SALEM NUCLEAR GENERATING STATION, UNIT NO. 1

AMENDMENT TO FACILITY OPERATING LICENSE

Amendment No.30
License No. DPR-70

SAFETY EVALUATION BY THE OFFICE OF NUCLEAR REACTOR REGULATION
RELATED TO AMENDMENT NO. 30 TO FACILITY OPERATING LICENSE NO. DPR-70

Figure B 3/4 2-1 TYPICAL INDICATED AXIAL FLUX DIFFERENCE VERSUS THERMAL POWER

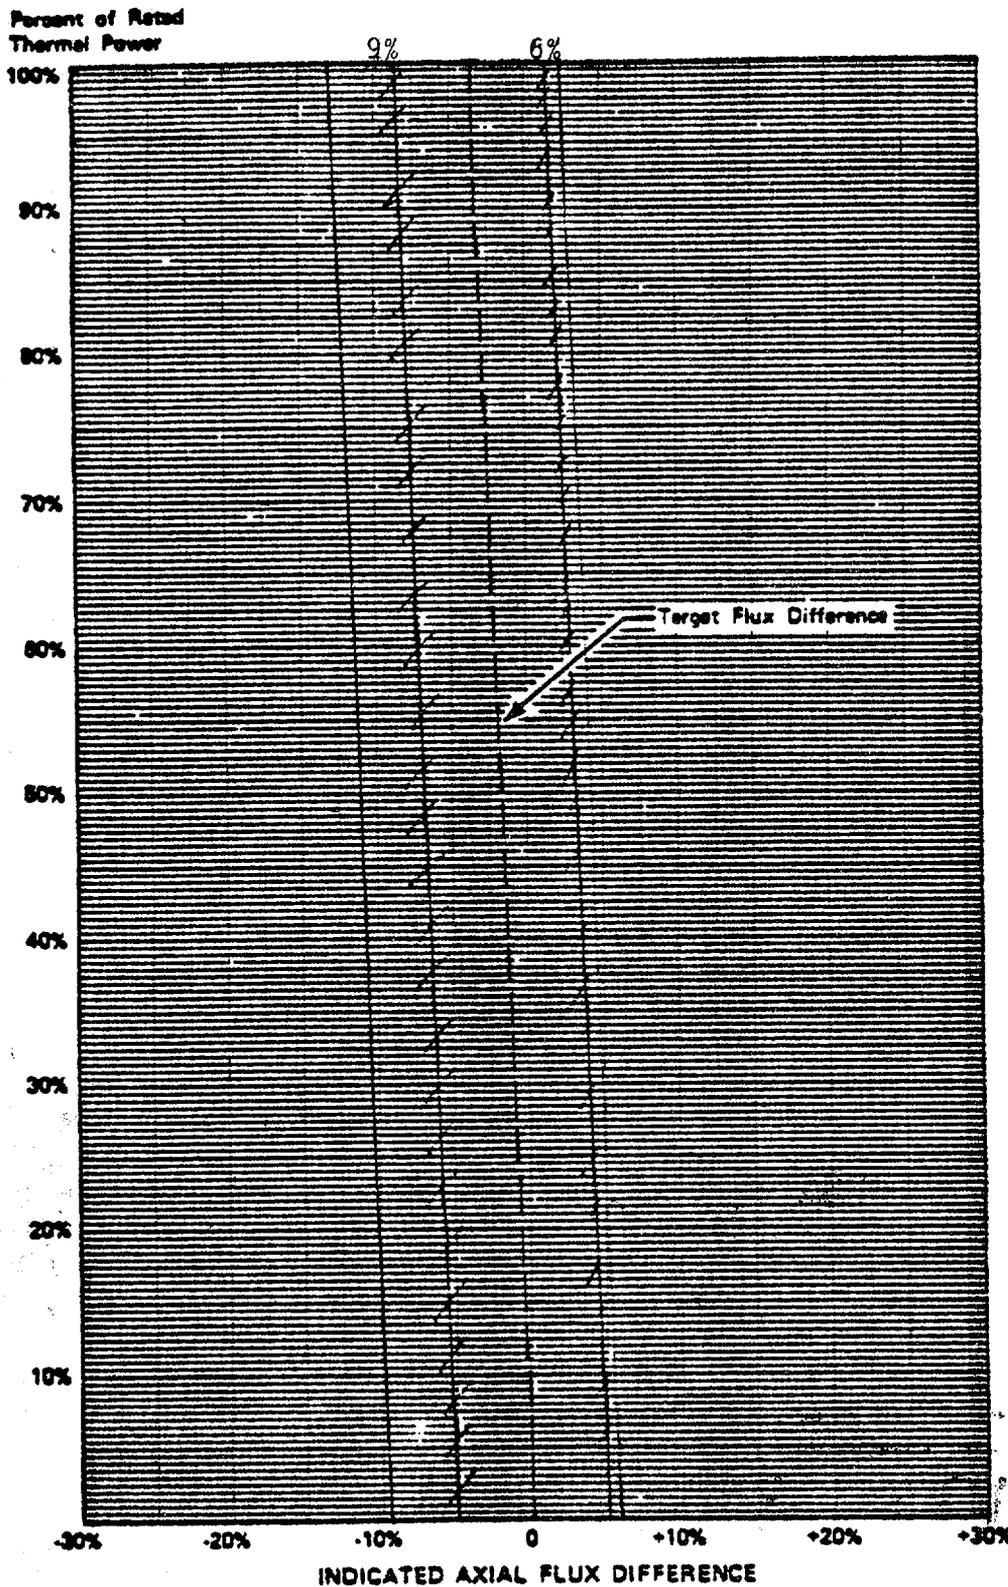
Although it is intended that the plant will be operated with the AXIAL FLUX DIFFERENCE within the +6, -9% target band about the target flux difference, during rapid plant THERMAL POWER reductions, control rod motion will cause the AFD to deviate outside of the target band at reduced THERMAL POWER levels. This deviation will not affect the xenon redistribution sufficiently to change the envelope of peaking factors which may be reached on a subsequent return to RATED THERMAL POWER (with the AFD within the target band) provided the time duration of the deviation is limited. Accordingly, a 1 hour penalty deviation limit cumulative during the previous 24 hours is provided for operation outside of the target band but within the limits of Figure 3.2-1 while at THERMAL POWER levels between 50% and 90% of RATED THERMAL POWER. For THERMAL POWER levels between 15% and 50% of rated THERMAL POWER, deviations of the AFD outside of the target band are less significant. The penalty of 2 hours actual time reflects this reduced significance.

Figure B 3/4 2-1 shows a typical monthly target band.
